Eng: David Rundle PC81070700 <User Ext. #3> <User Ext. #4> <User Ext. #5>	Paul, C. Buff Inc. 2725 Bransford Ave. Nashville, TN 37204
Sheet Title: RadioRemote One LCD	
Sheet File Name: 1x1cd.sch	
Sheet Creation Date: 02/24/99	
Sheet Revision: B	
Sheet Revision Date: 10/12/99	
	SHEET 3 OF 5

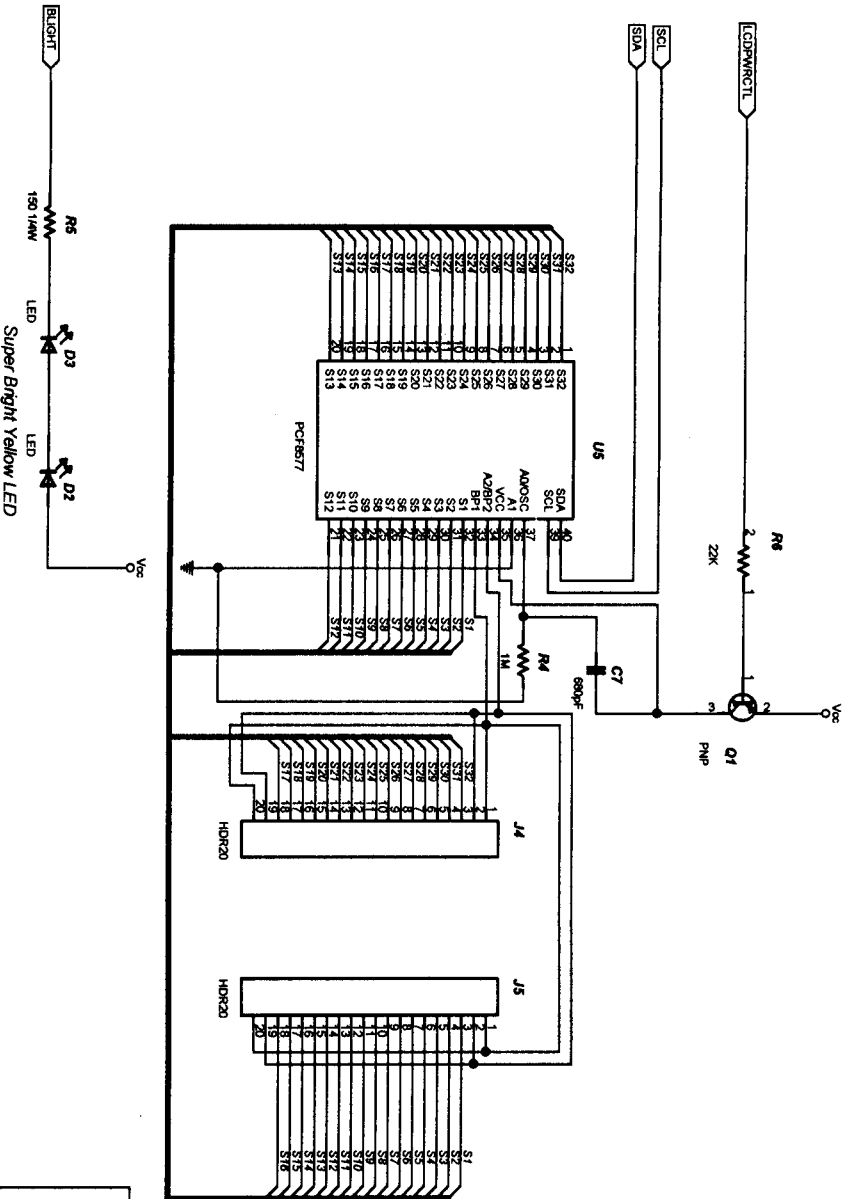
Rev D Change R5 from 75ohm to 27ohm
 Rev E Add LCD Power Control Change R5 from 27ohm to 150ohm
 And change to Super Bright LED
